Project Amendments  
BLD2021-03082  
APN 037-333-200  
130 Bridgeport Dr.  
Half Moon Bay, CA 94019

## SUMMARY OF CHANGES

November 2, 2023

EXTERIOR 3D  
VIEW

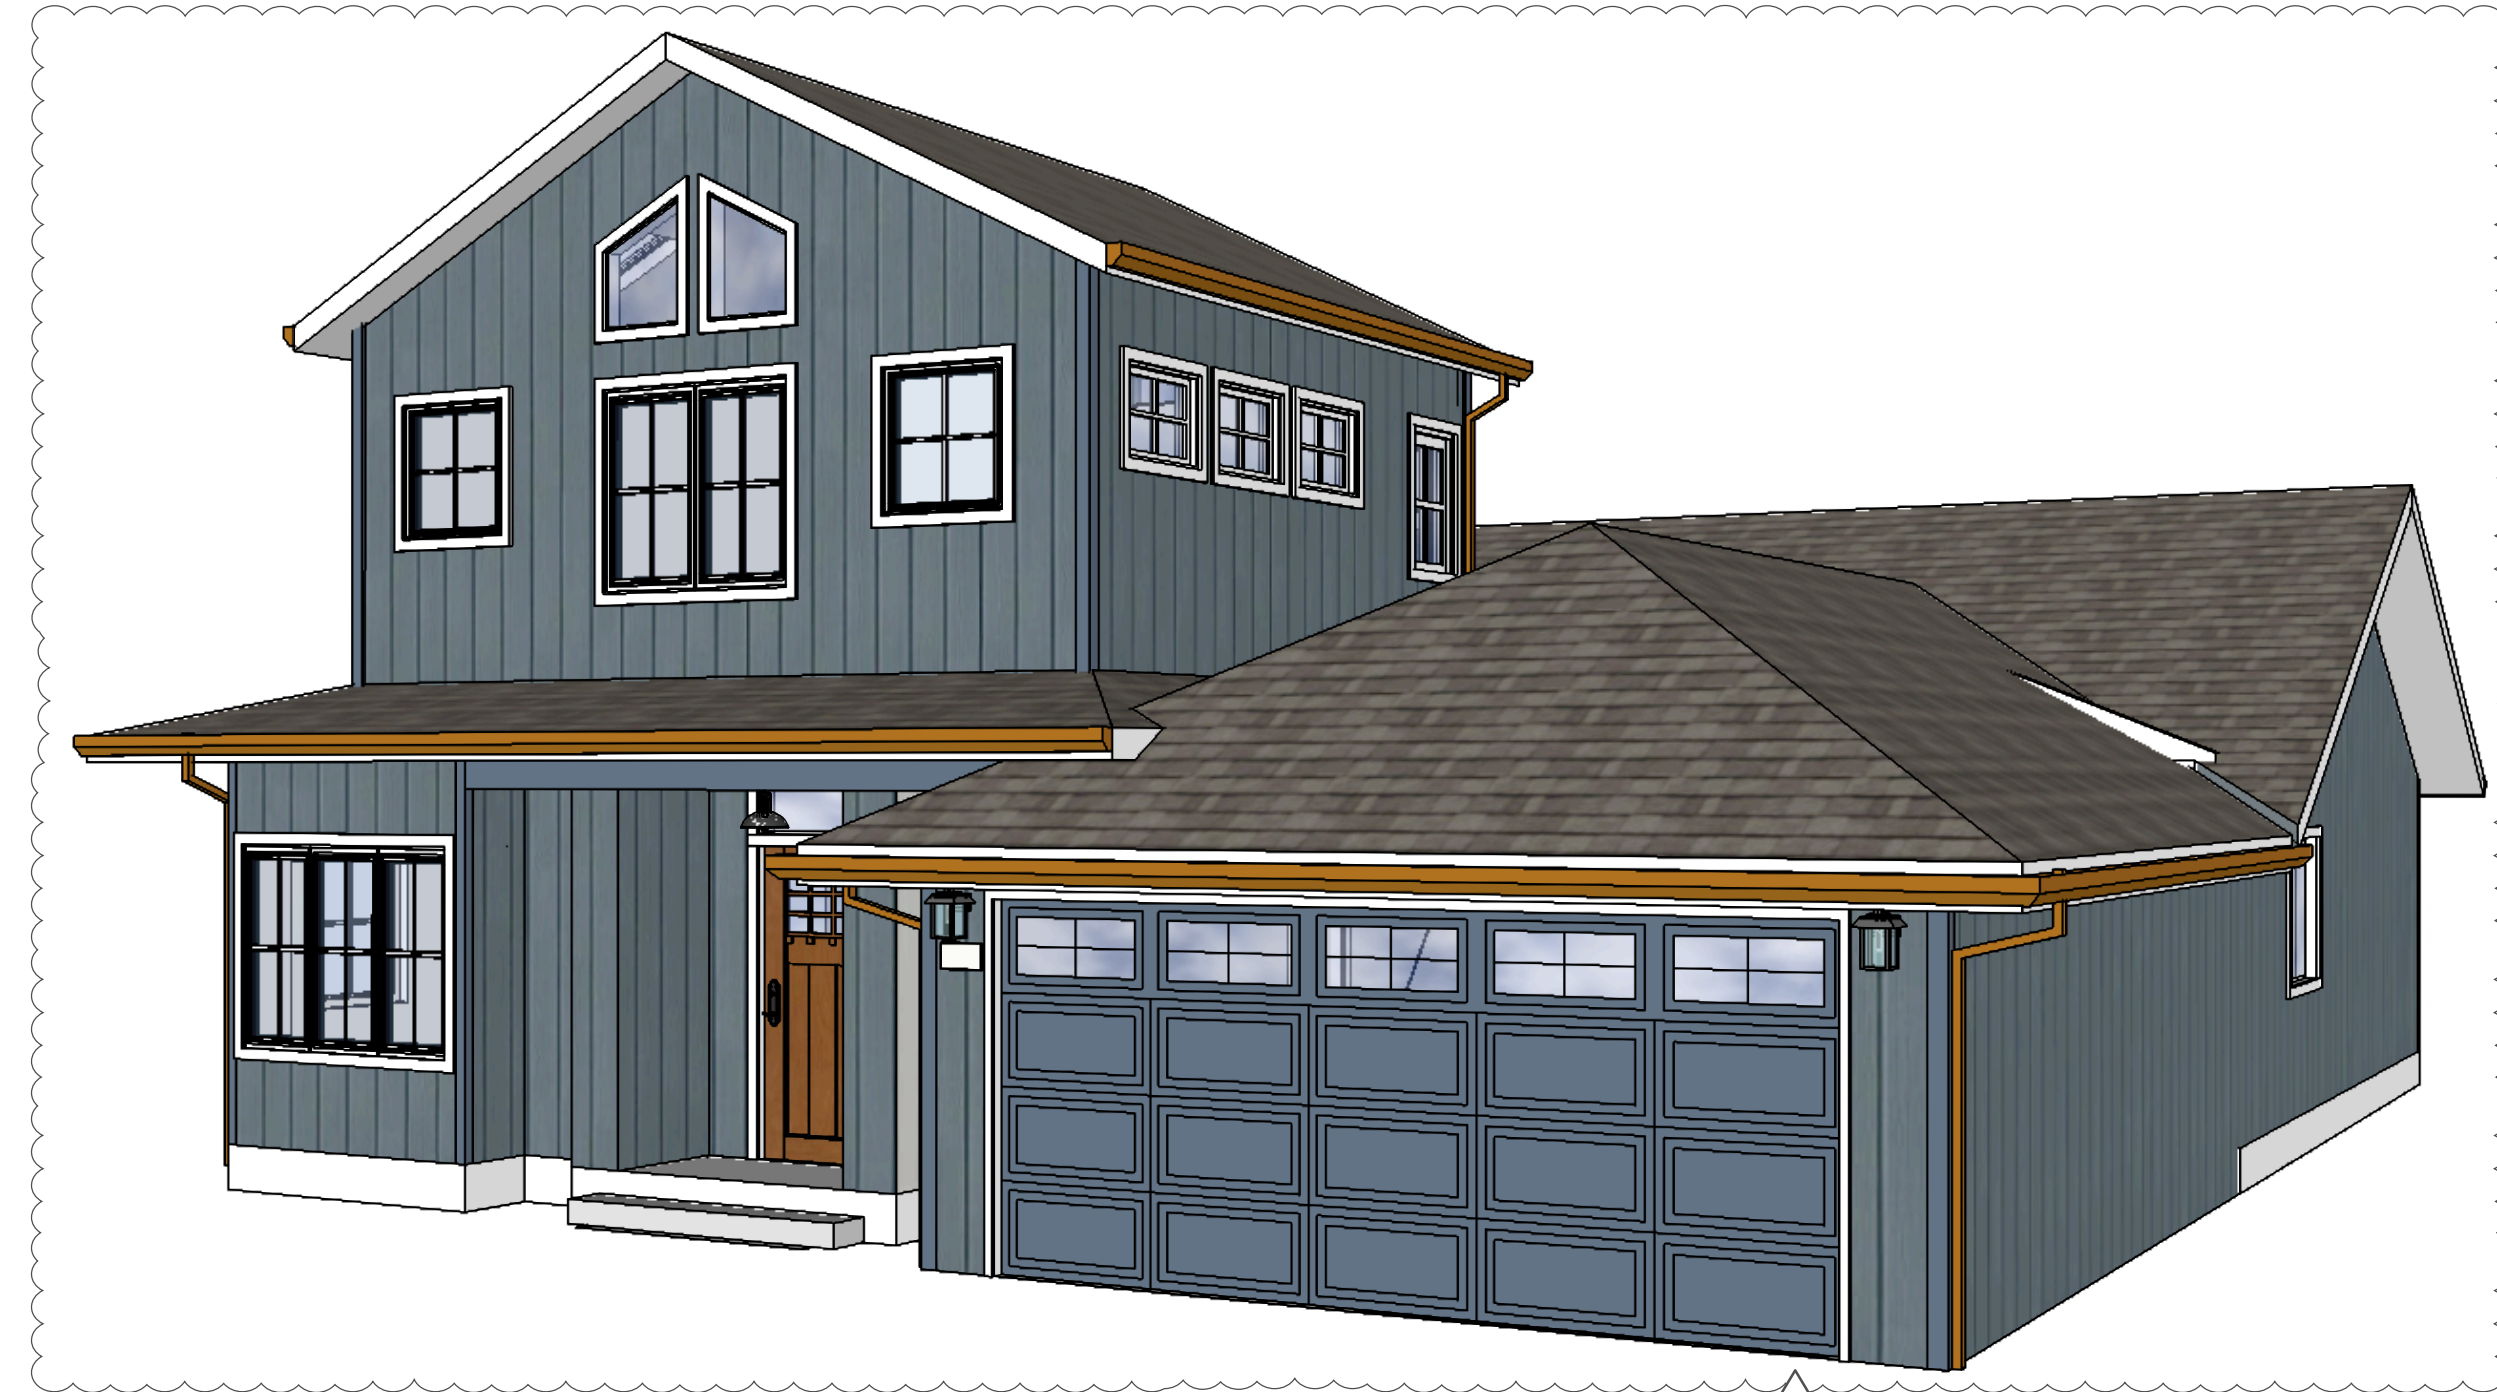
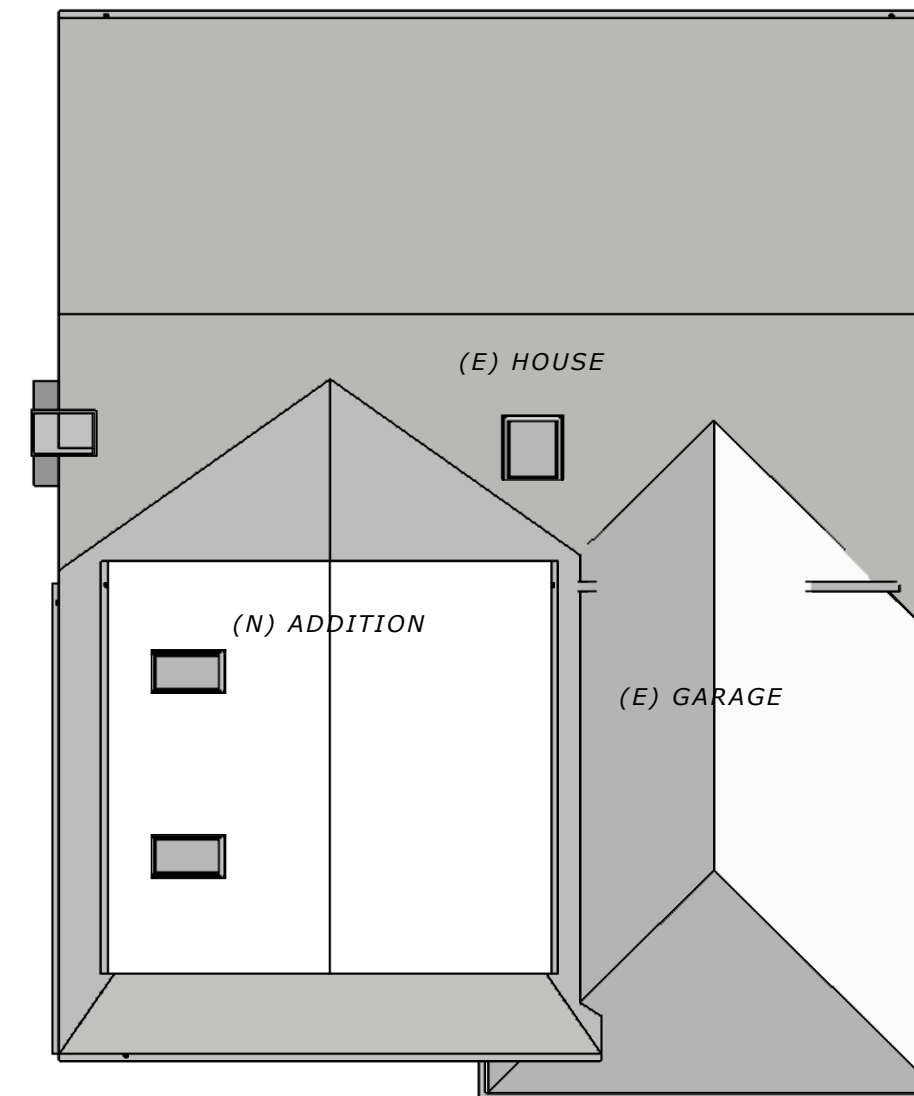
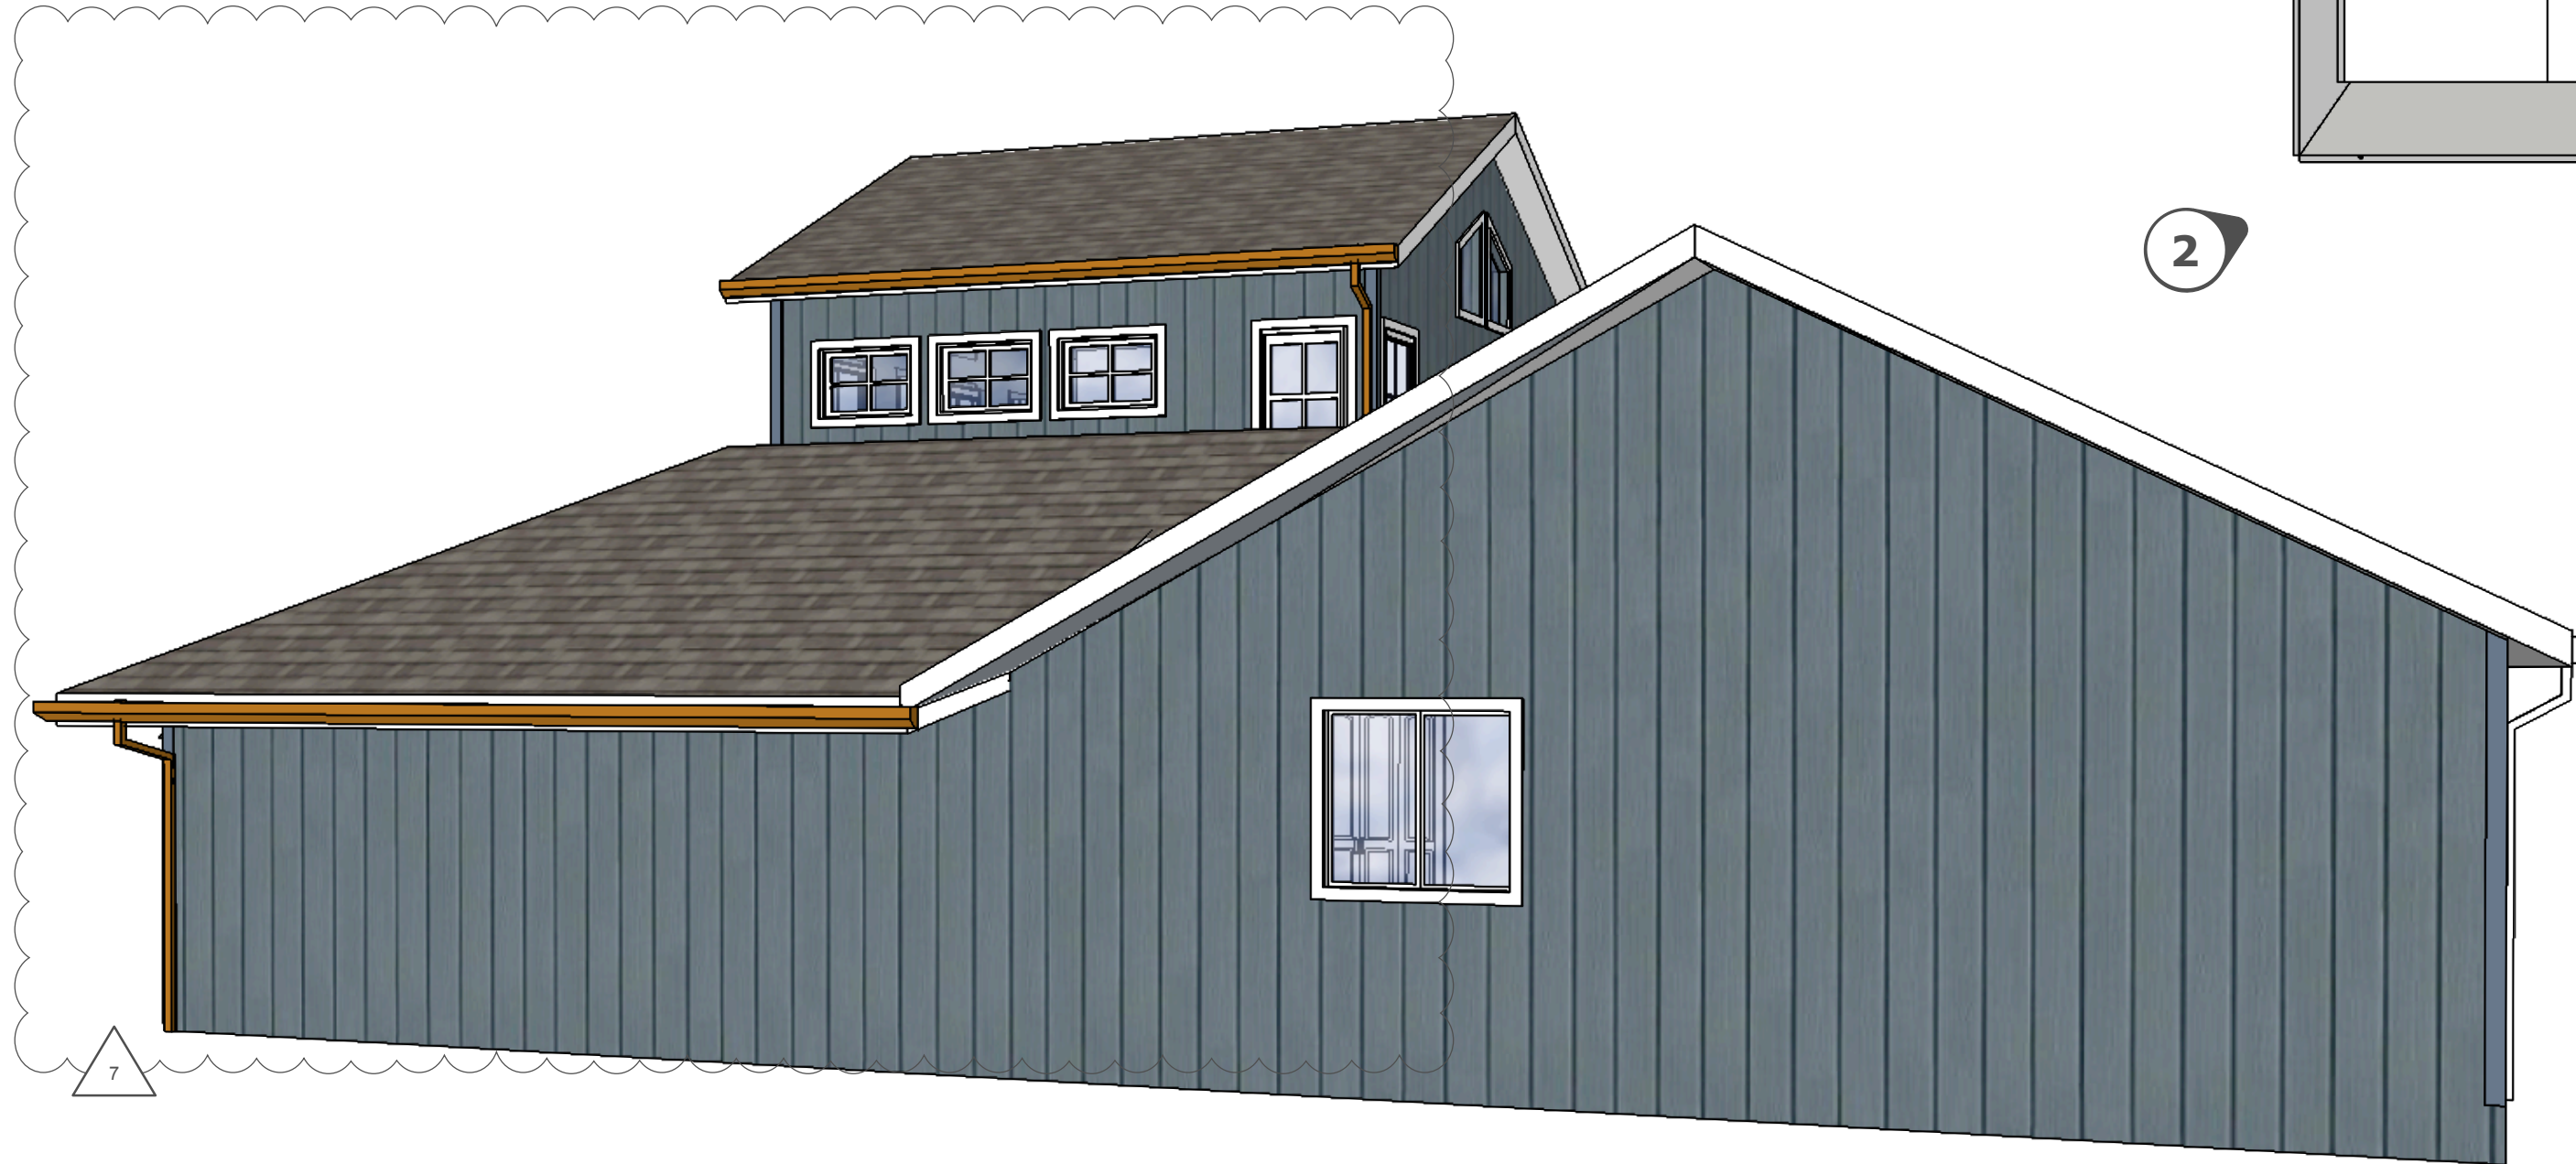
The second proposed change is our paint plan, roof color, and gutters. These changes are noted on pages A1.01, A3.02, A8.02 Color/Material Board and Statement of Compliance – DR STDS. The approved color was Newburyport Blue for the siding and Extra White for the trim and fascia. The colors we chose are Benjamin Moore Blue Note for the siding, which is grayer than Newburyport Blue but is very similar. For the trim and fascia, we chose Benjamin Moore Classic Gray, which is considered an off-white, as you can see in the Color/Material Board on page A8.02. After design consultation and research, we chose an off-white for the trim because a true white would be too bright in contrast to the blue siding.
